**MONTGOMERY COUNTY PLANNING DEPARTMENT**

**FROM:** Molline Jackson,  
Art Review Panel Coordinator

**PROJECT:** Bainbridge Bethesda and St. Elmo Apartments.  
Site Plans Nos. 82009011B and 820170030

**DATE:** April 12, 2017

**Figure 1 – Existing Conditions & Existing Public Artwork**

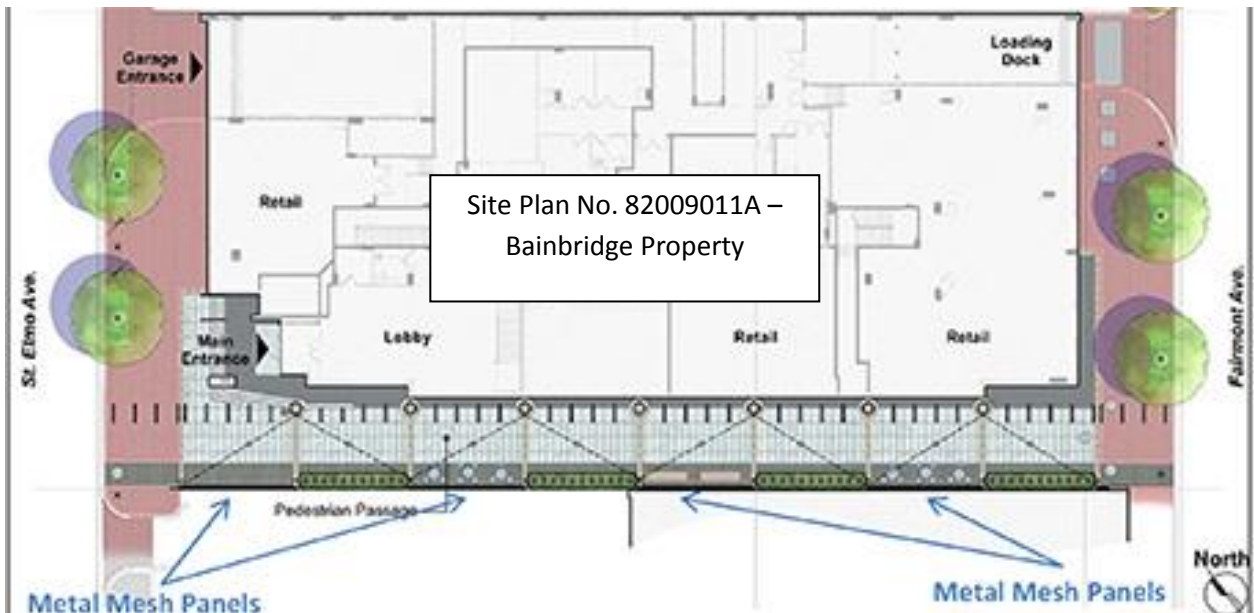
- This existing artwork was intended to provide screening along the property line, between the two properties. This barrier is no longer needed at this location (*reference Figure 1 above*).
